# DHDC 23-8201

### CERTIFICATE OF APPROPRIATENESS

**RE: Application Number 23-8201; 761 Whitmore; Palmer Park Apartment Buildings Historic District**

761 Whitmore-Rosemor Apartment Window Replacement

2/A700 photo documentation of windows

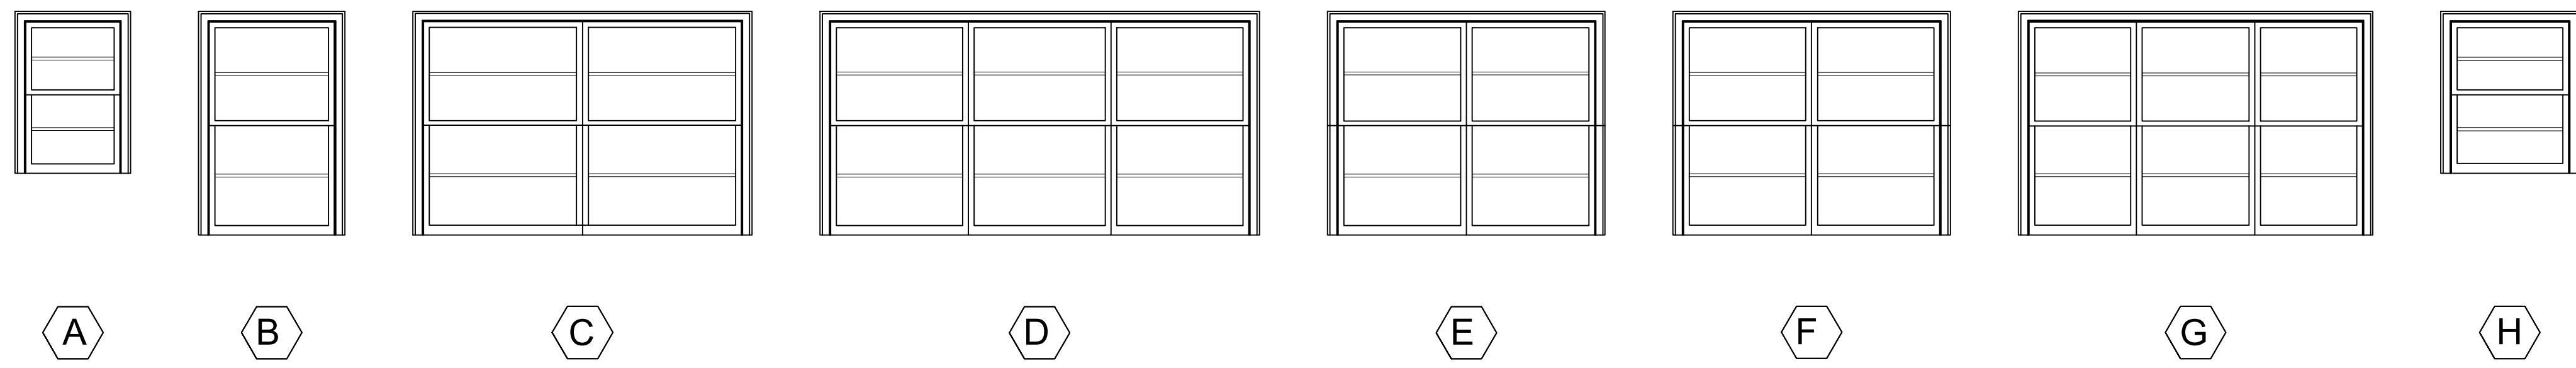
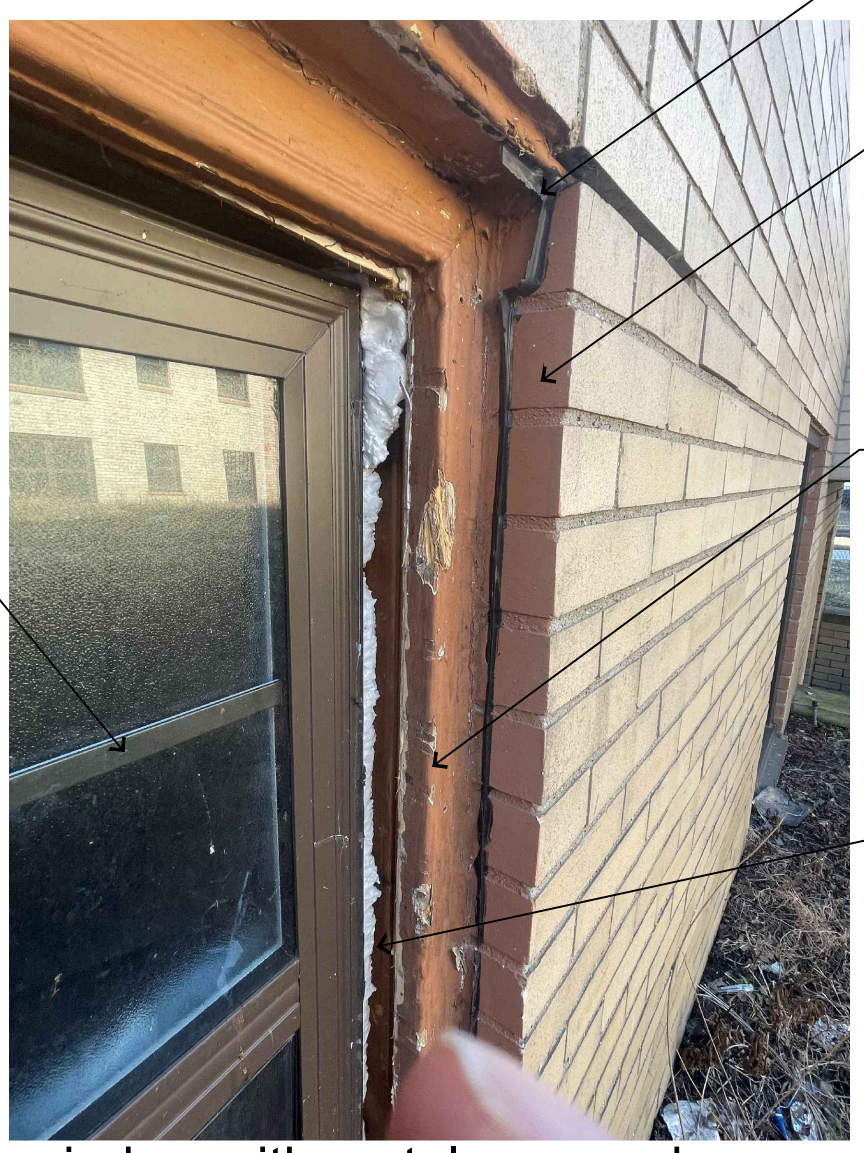
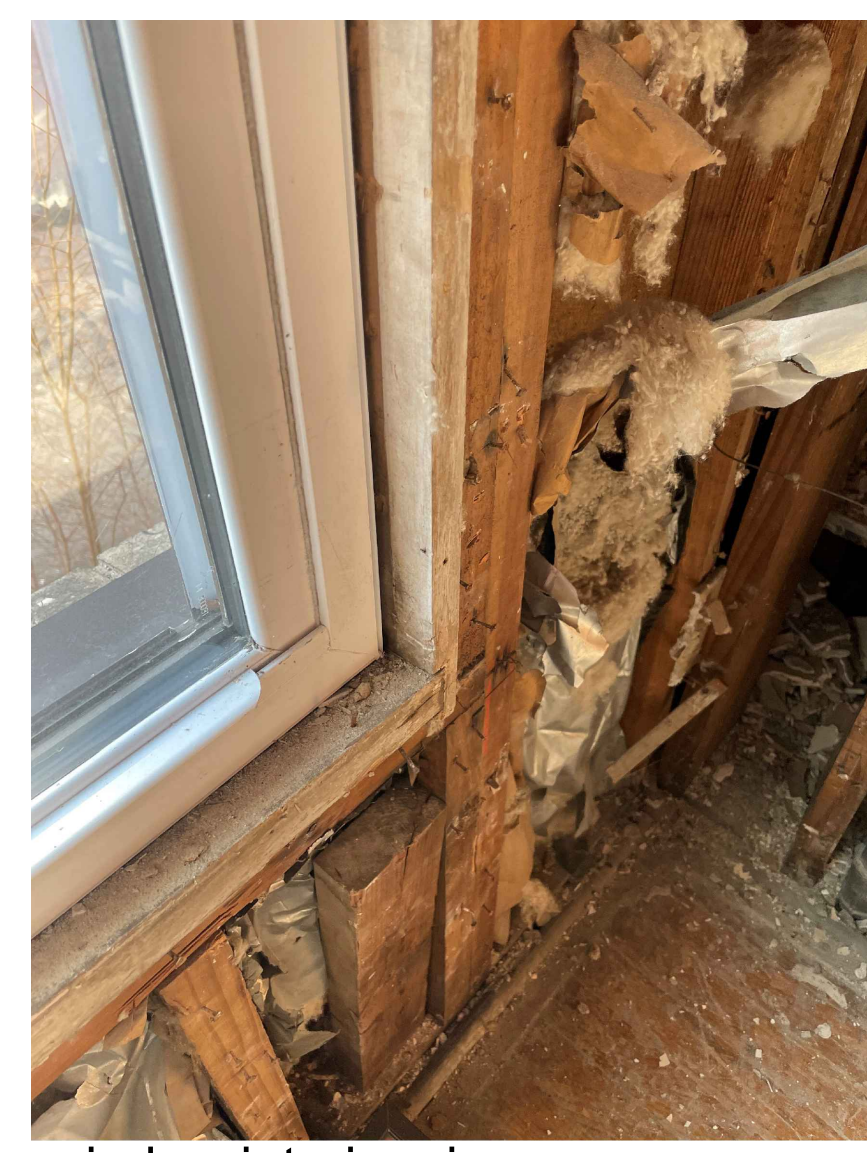
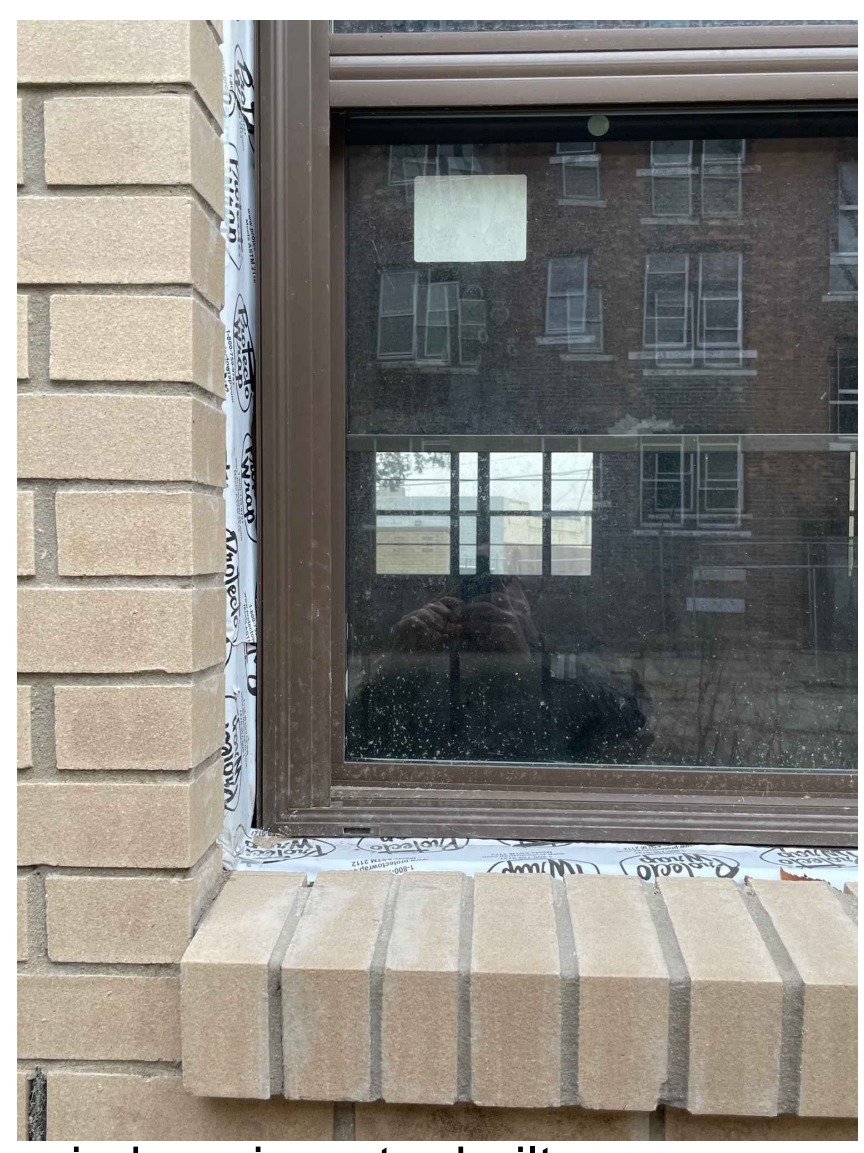
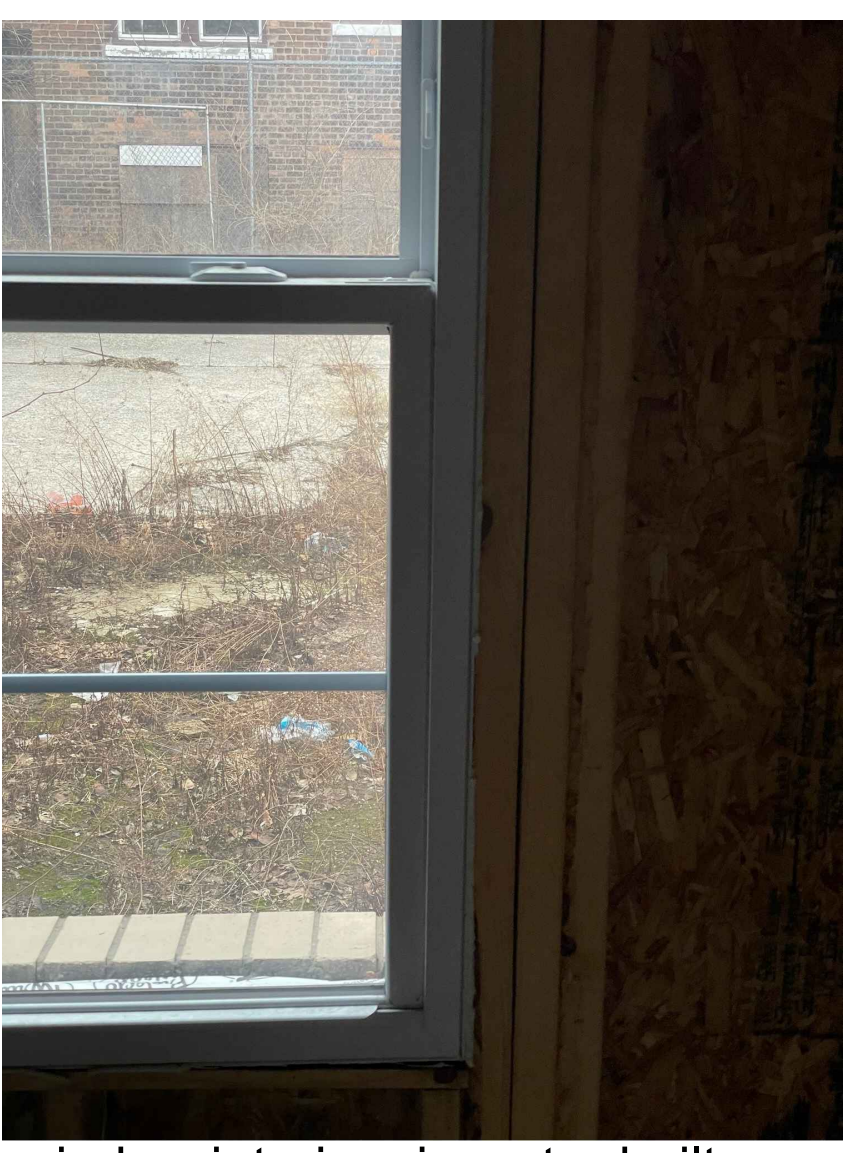
- ***The cleaning/removal of paint from any painted masonry surface of the painted masonry shall be done using the gentlest means possible and shall follow Secretary of the Interior Standards guidelines. The applicant shall provide HDC staff with the final specifications/proposal for the areas to be cleaned of paint for review and approval prior to the issuance of the permit.***
- ***The cladding around the windows is to be removed and the remaining brick mould to be restored or replicated with paint removed from the windowsills.***
- ***Exterior muntins be applied over the interior muntins in either 5/8” or 7/8” in width provided they are applied by a Quaker Windows employee or representative. This shall be reviewed and approved by HDC Staff.***
- ***No brick moulds be applied to the 19 windows that were incorrectly constructed at the rear of the building per the attached drawings.***

- **BRICK MOULDS AND STOOL (CURRENT WINDOW CONDITION)**  
 We propose to remove the current brick metal brick mould around each window that have them. We selected one window and removed the metal surround and found that the original wood brick mould and window stool remained. With this discovery, we plan on scraping the existing paint, repairing any blemishes, and repainting the wood. For any pieces that need to be replaced, we will source or have milled replacement pieces. Each window will be inspected and, if required, readjusted within the opening. A flat stock filler of 1" x 1/2" wood will need to be installed between the back side of the brick mould and the window frame. This will be painted to match as well. The windows will then be recaulked with a matching color.

- **WINDOWS AT REBUILT AREAS**  
 There are 19 windows that were installed in the rebuilt sections of the building. The new brick work was installed to the size of the new window openings. A wood flat stock filler of 3" x 1/2" will be installed between the back side of the brick and the window frame. This will be painted to match as well. The windows will then be caulked with a matching color.

1/A700 window elevations

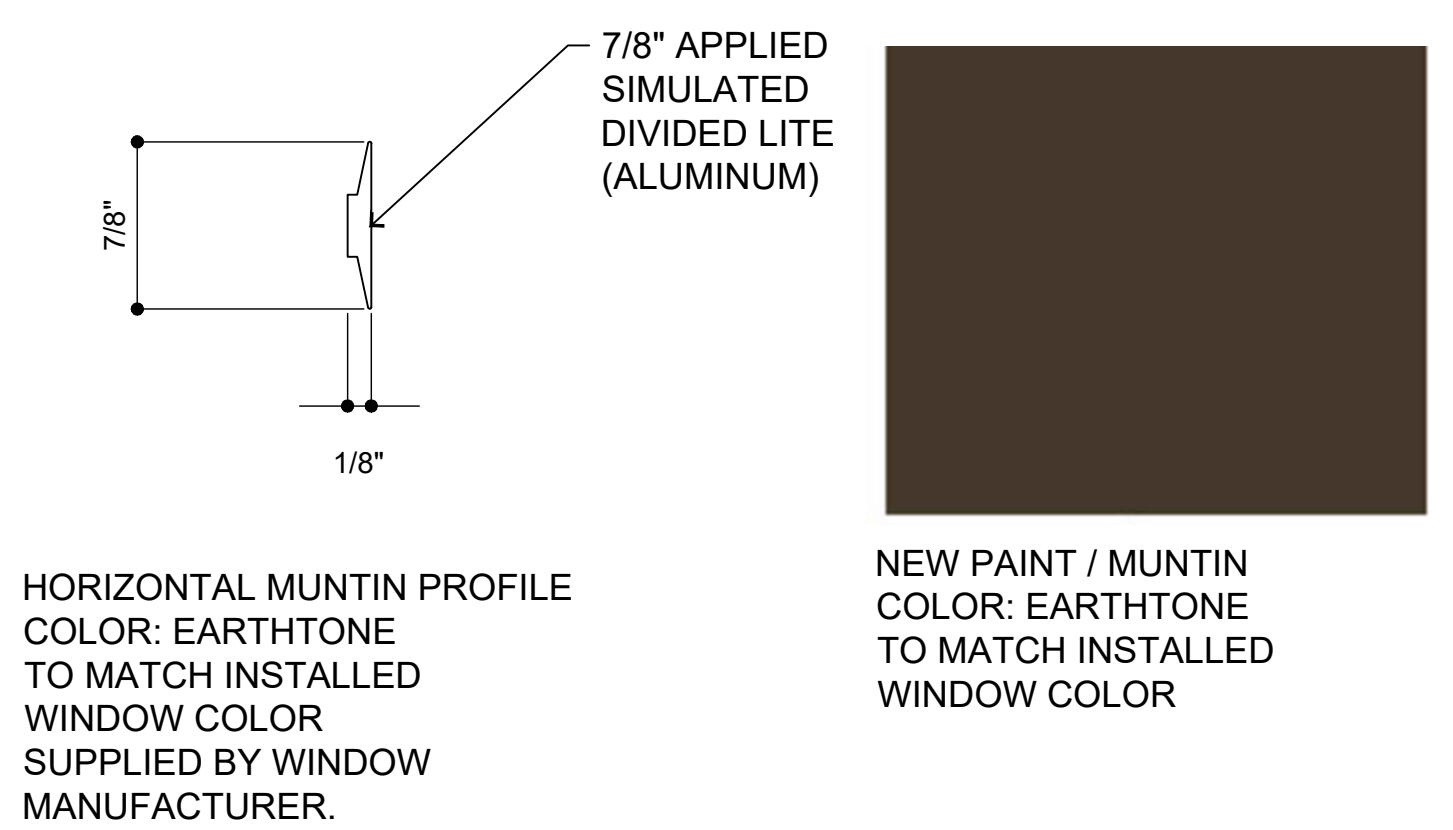
- ***The replacement of wood windows with double-hung, vinyl units with between the glass 2/2 muntins, per the attached drawings and details, color earthtone.***
- ***The application of 7/8” wide external, 2/2 muntins to the external glass panes supplied by the same window manufacturer, per the attached drawings and details, color to match the windows.***
- ***The removal of brake metal coverings and the restoration of each brick mould around the remaining brick moulds, per the attached drawings and specifications. Paint and re-caulked to match color of windows.***
- ***The installation of wood flat stock filler of 19 windows at rear of building per attached drawings and specifications. Paint and re-caulked to match existing color of windows.***
- ***Strip all existing brick rowlock and stone sills that were painted to restore their original color.***

- **MUNTINS**  
 We propose to add a 7/8" wide external simulated divided lite to the exterior panes matching the current 2/2 horizontal muntin bar pattern. The current internal muntin is 5/8" wide and will be obscured by the new external muntin. The color will match the current window manufacturer color of Earthtone. The muntin profile will be secured to the glass with a 3M adhesive tape and supplied by the window manufacture. Adding an exterior applied SDL muntin will give the 3d visual division of the glass pane matching the prior window look. A profile detail of the muntin is provided with the attached plans. This will be typical for all 466 windowpanes. All windows have installed a permanent window stop limiting the opening to 4". Even if the window is allowed to fully open, the installed muntin will not interfere with this operation.
